Released Engineering Change Notice

Product	GL2800
---------	---------------

Title	Master Distribution Link removal to accommodate Group pcb up-issue
-------	---

Date	4th July 2004
------	---------------------------------

TITLE: **GL2800 MASTER DISTRIBUTION PCB**
 PAGE:

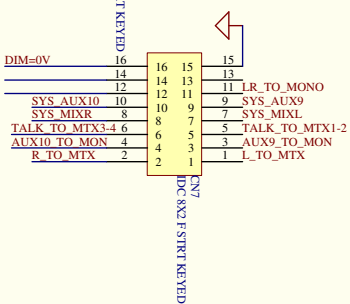
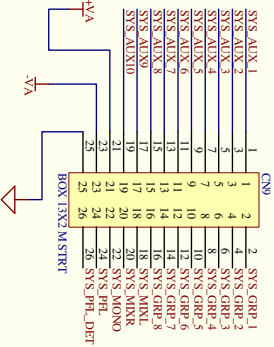
ON 003-370 PCB assy GL2800 master distribution, remove LK1 & LK2 from the build sequence. This will enable the pcb assy to be used with the issue 4 Group 1-2 pcb's. Up issue C5871_1 to c5871_1_1.

In up issuing the Group pcb to 4, the meter signal is taken to pin 10 on the box header which is linked to ground on the master distribution pcb.

Assy	Desig	Deleted (y)	Part no./description
003-370	LK1, LK2	Y	AH0070 TC LINK 22SWG
